Subject: Letter of Clarification No. 1 to Invitation to Bid No. S50-C23560, Concrete Repair Services for Various Departments

Letter of Clarification No. 1
Invitation to Bid No. S50–C23560,
Concrete Repair Services for Various Departments

Dwg. # 100 Sheet 1 of 1 Fire Station Driveway

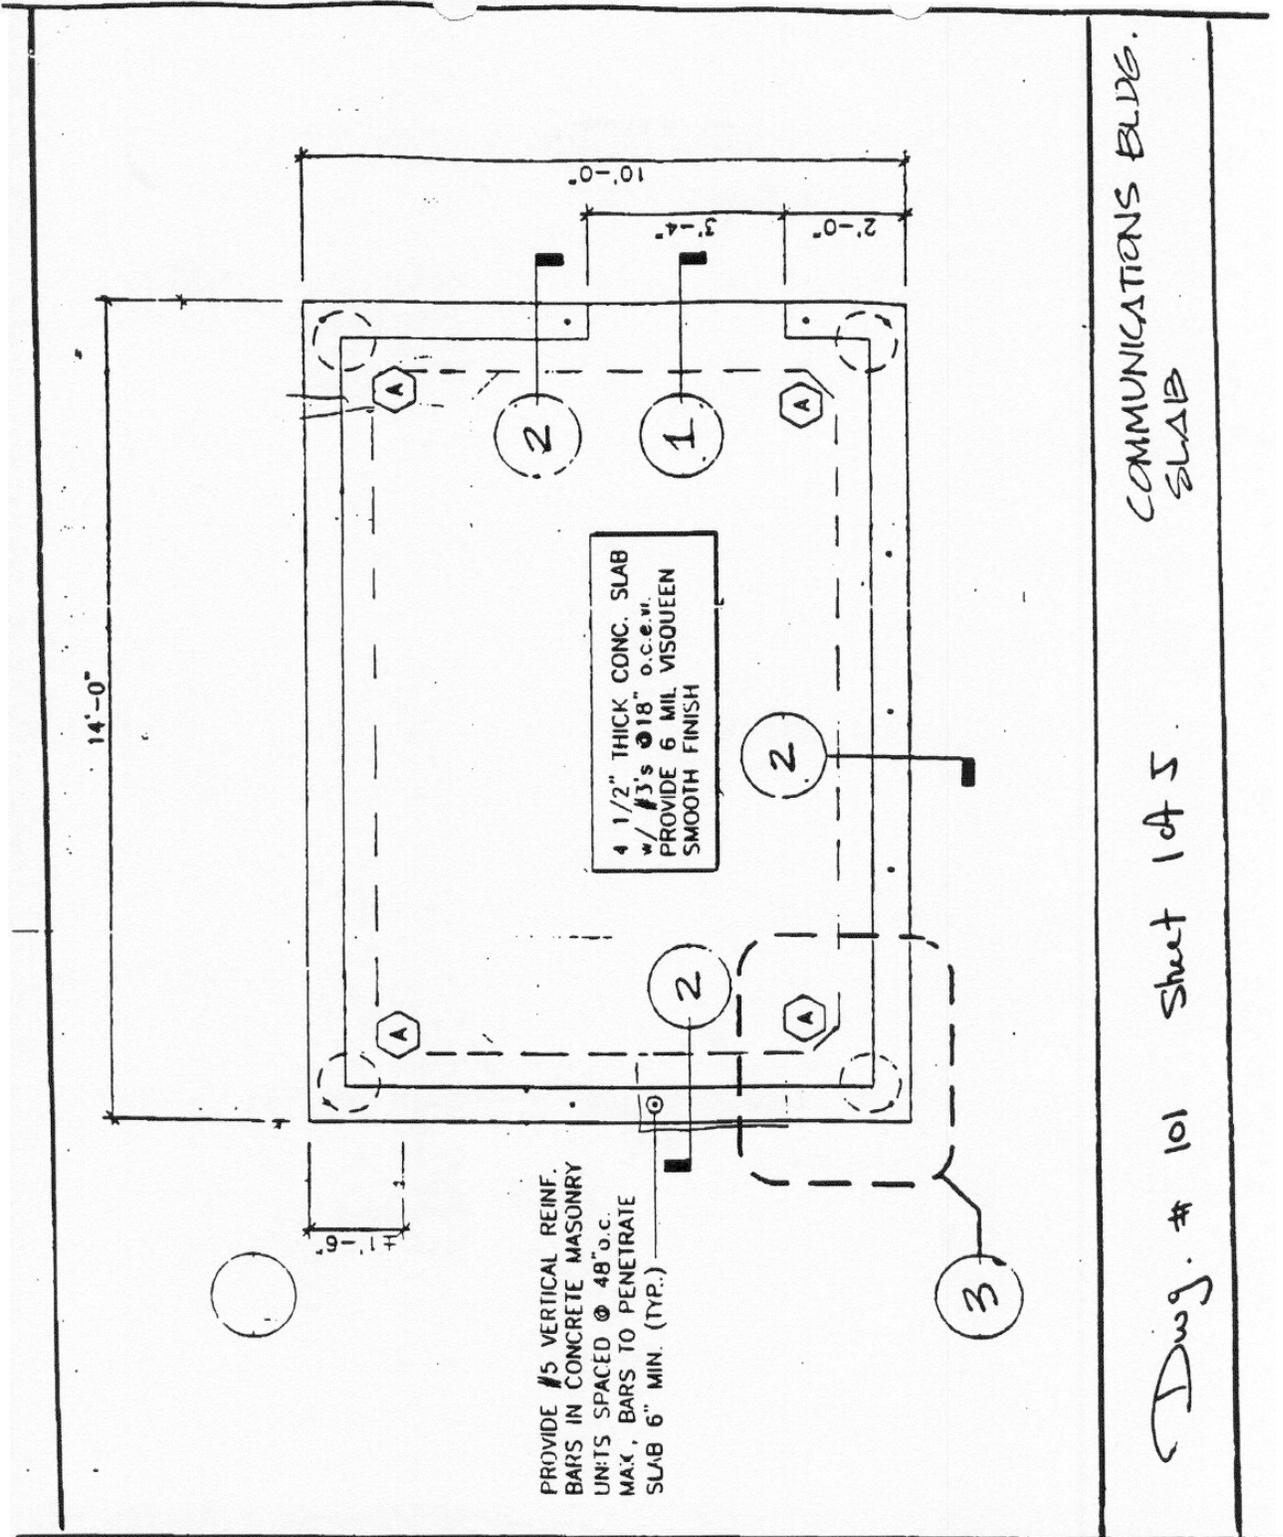
Question No. 1 Line Item 5: The description is mixed up. The unit is shown "Foot" which is incorrect. Reference drawing is #100, there is no such drawing in the document?

Question No. 4 Line Item 15: The description is mixed up. The unit is shown "Foot" which is incorrect. Reference drawing is #100, there is no such drawing in the document?

Answer: The unit of measure is as shown "Square Foot" which is correct. Drawing No. 100 is now attached. (*See the attachments*)

Answer: The unit of measure is as shown "Square Foot" which is correct. Drawing No. 100 is now attached. (*See the attachments*)

Dwg. # 101
Sheet 2 of 5

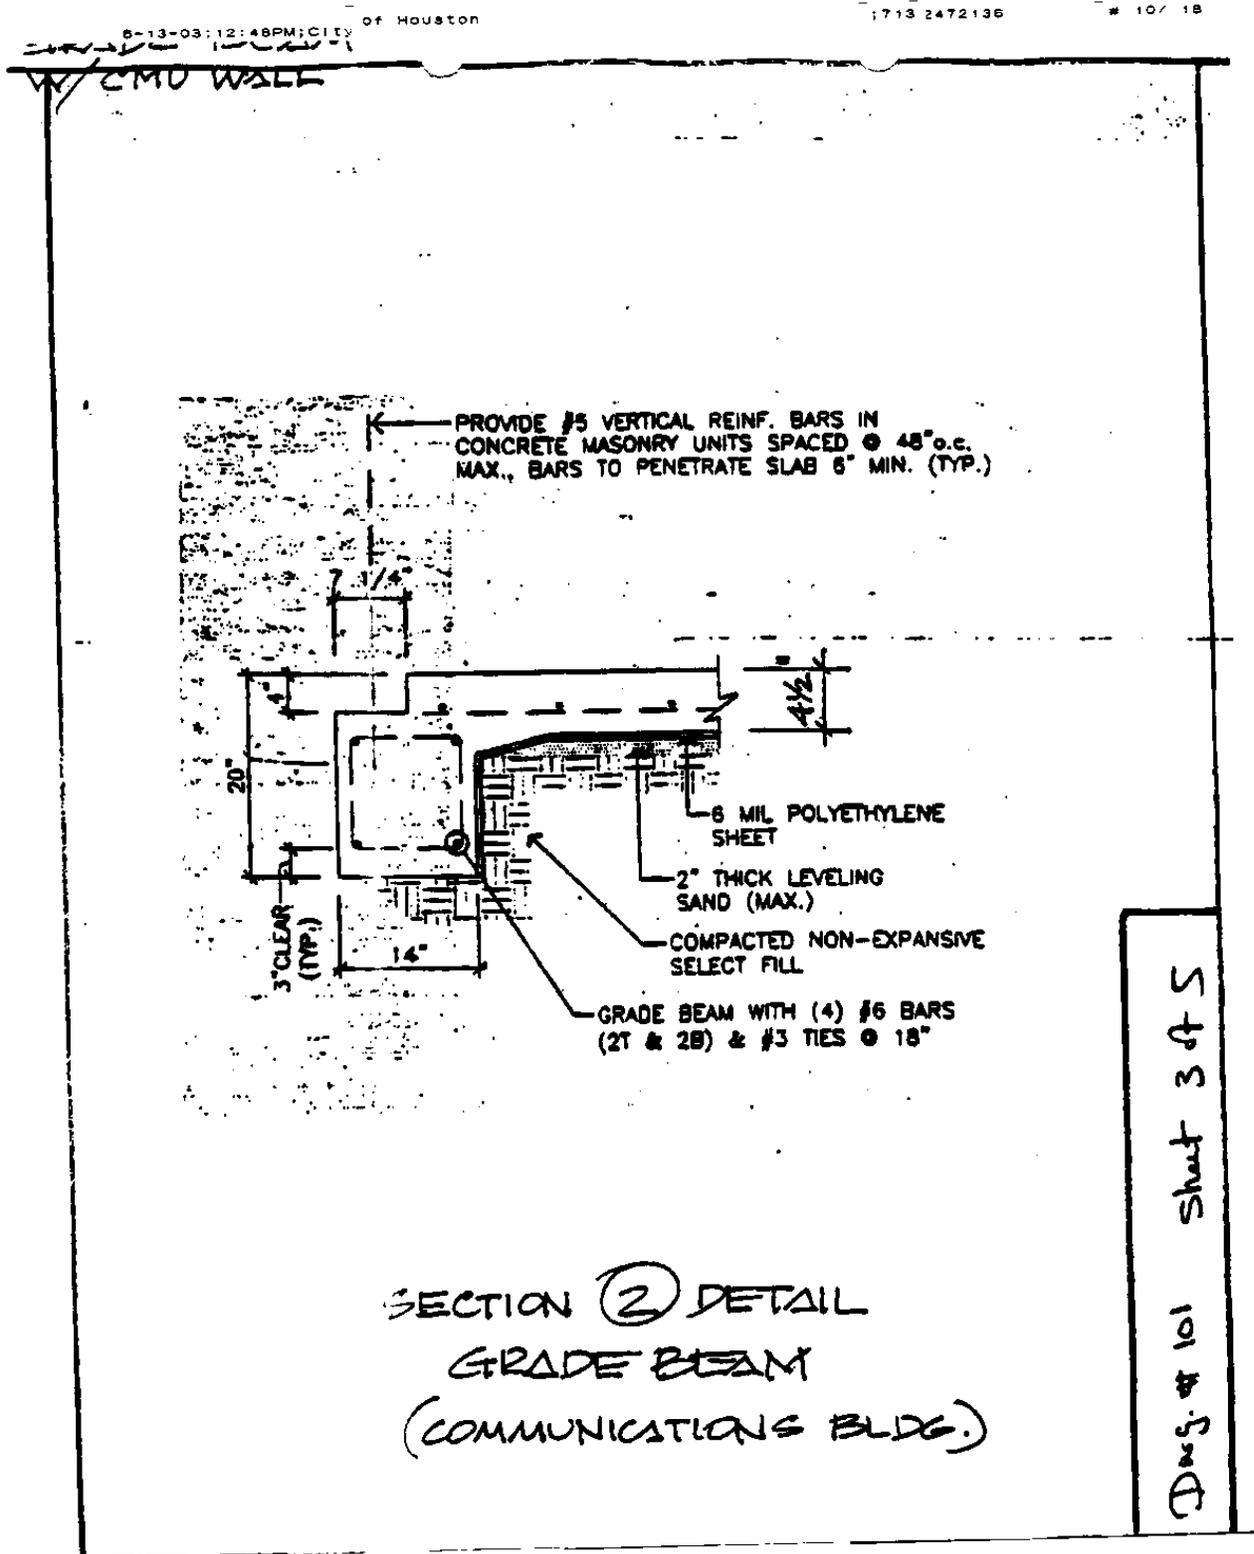
Question No. 5 Line Item 18: Reference drawing is #101, there is no such drawing in the document?

Answer: See the attachments.

Change sentence at top of drawing to read: "Provide #5 vertical reinforcement bars in concrete masonry units spaced 32" o.c. maximum, bars to penetrate slab 6" minimum (typical).

Dwg. # 102

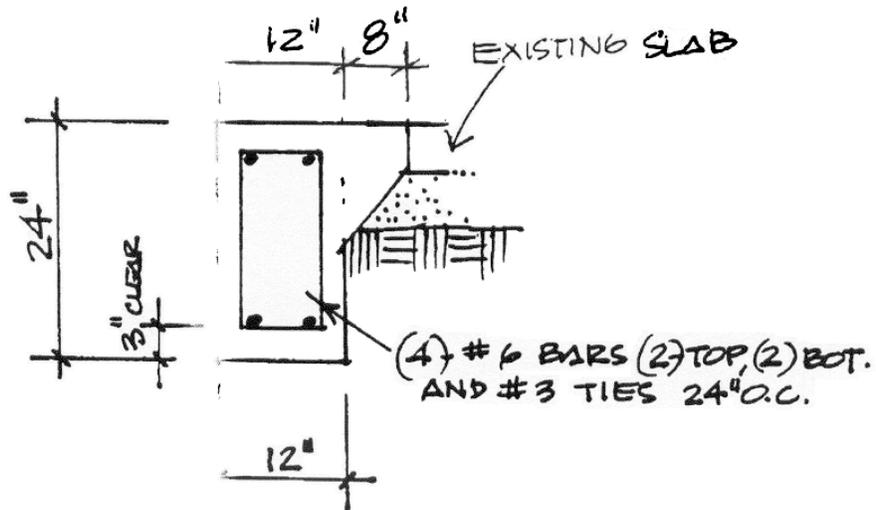
Question No. 8 Line Item 21: Reference drawing is #102, there is no such drawing in the document? Please provide quantify?

Answer: Drawing No. 102 is attached hereto. Also, see the revised electronic bid form for estimated quantities.

Dwg # 103
Foundation Repair
Sheet 1 of 1

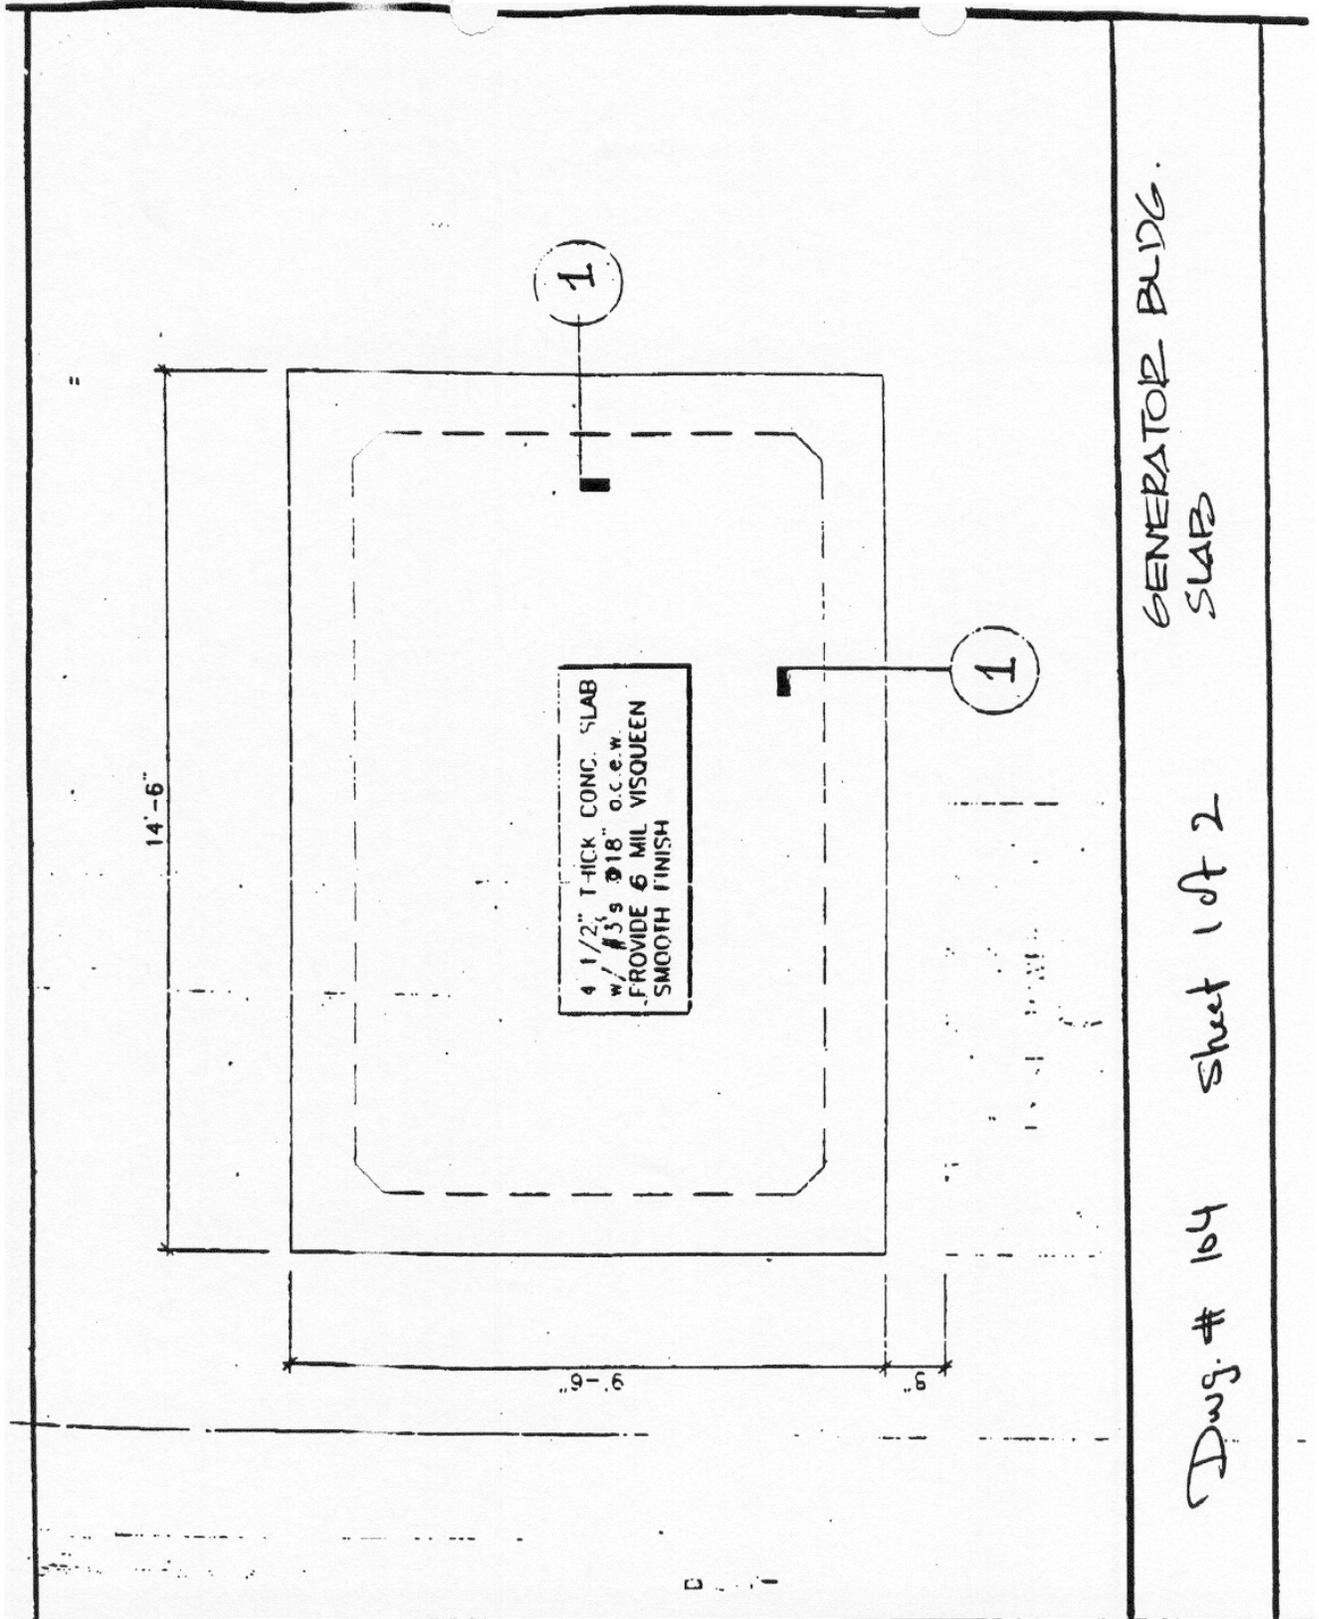
Question No. 2 Line Item 6: Reference Drawing is #103, there is no such drawing in the bid document. Please provide quantity?

Question No. 7 Line Item 20: Reference drawing is #103, there is no such drawing in the document? Please provide quantity?

Answer: Drawing No. 103 is attached hereto. Also, see the revised electronic bid form for estimated quantities.

Answer: Drawing No. 103 is attached hereto. Also, see the revised electronic bid form for estimated quantities.

Dwg # 104
Sheet 2 of 2

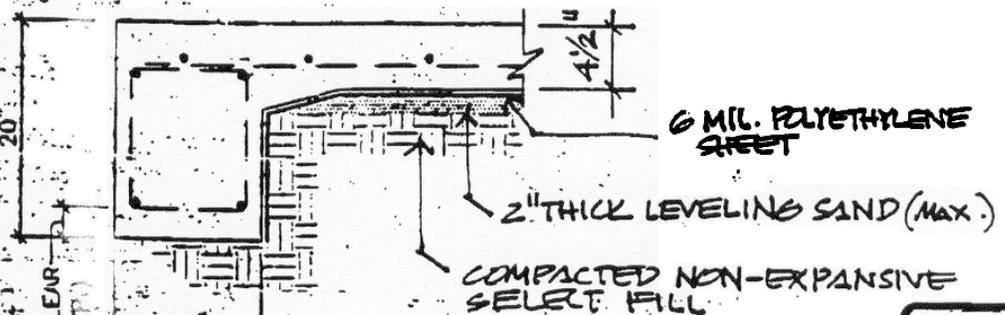
Question No. 6 Line Item 19: Reference drawing is #104, there is no such drawing in the document?

Answer: See the attachments.

DRAWING No. 106

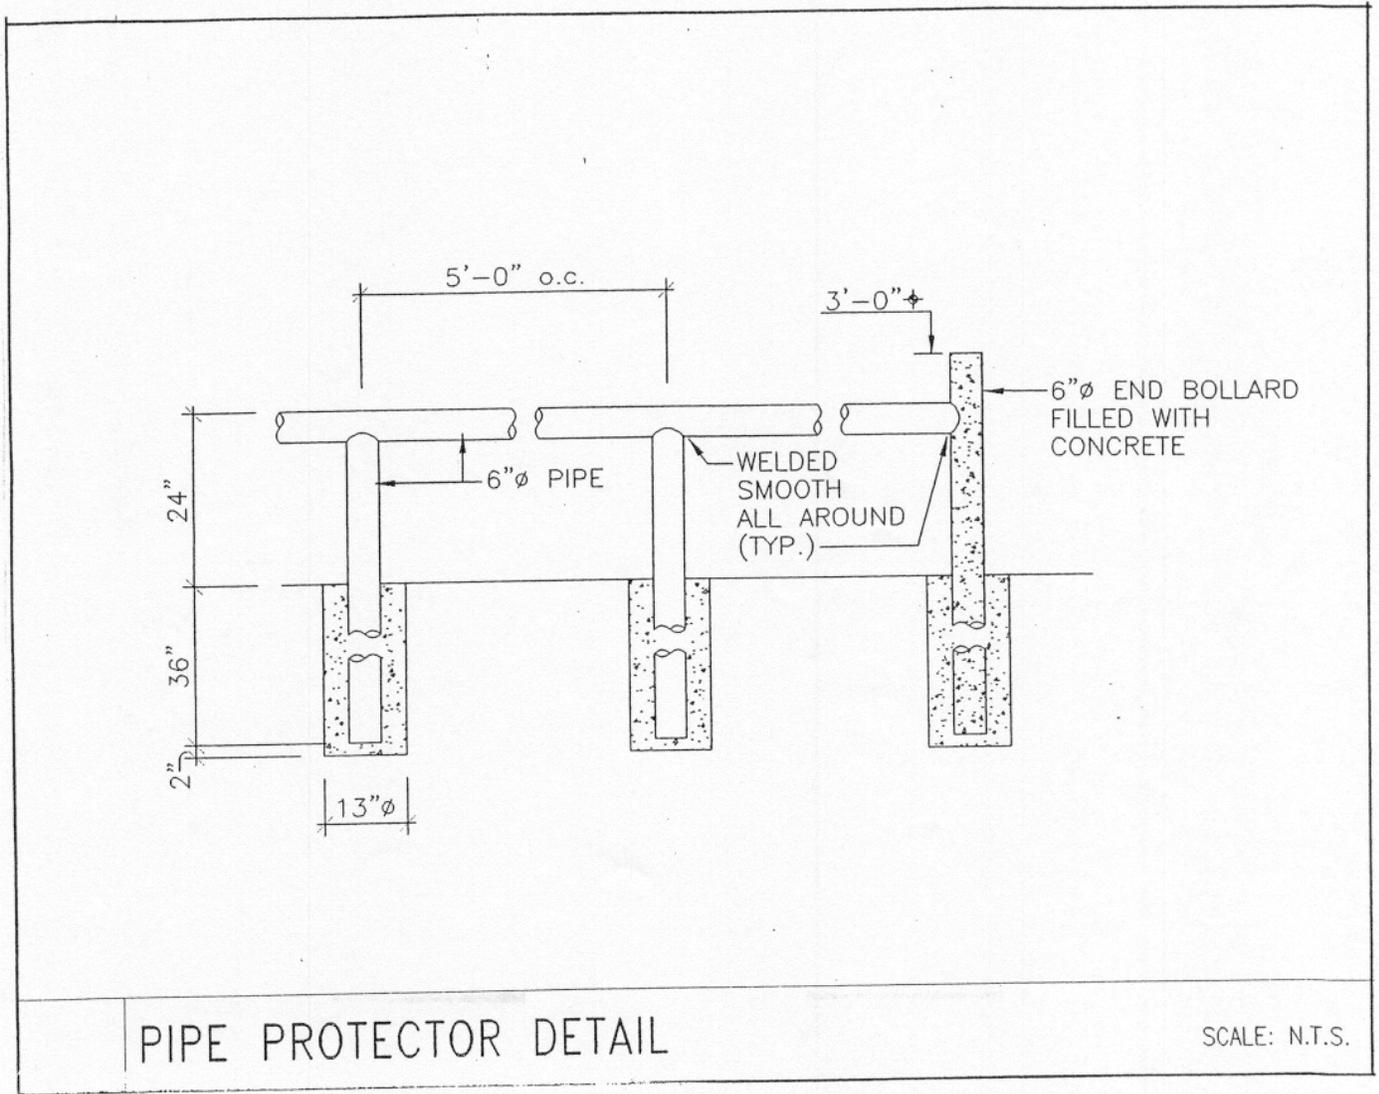
Question No. 9 Line Item 26: Reference drawing is #106, there is no such drawing in the document? Please provide quantity?

Answer: Drawing No. 106 is attached hereto. Also, see the revised electronic bid form for estimated quantities.

DRAWING No. 107

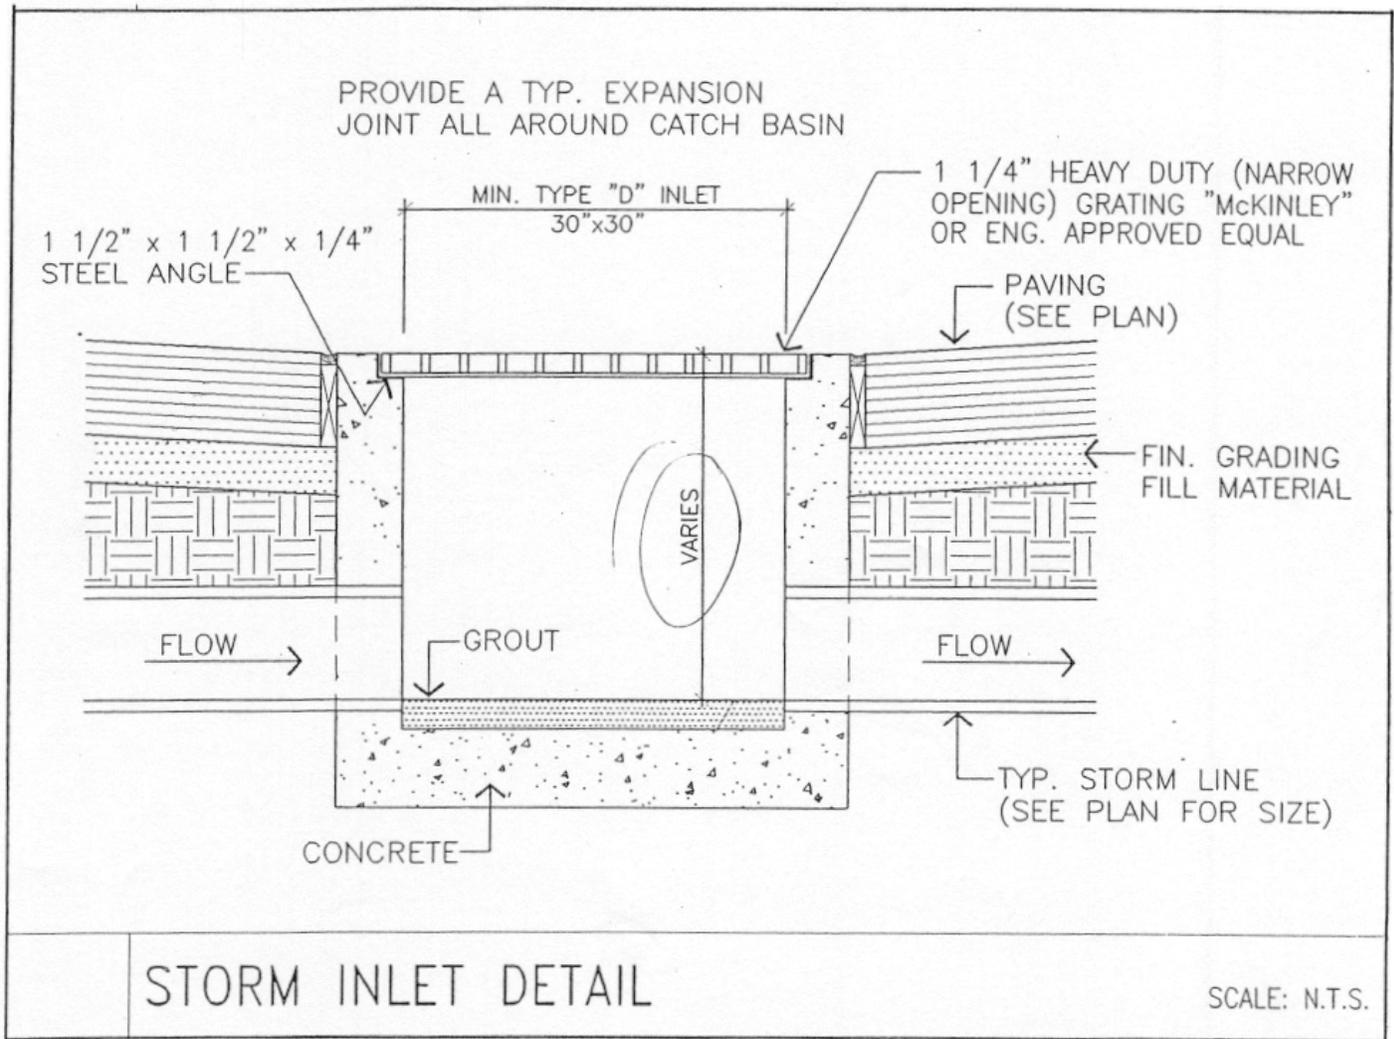
Question No. 10 Line Item 30: Reference drawing is #107, there is no such drawing in the document?

Answer: Drawing No. 107 is attached.
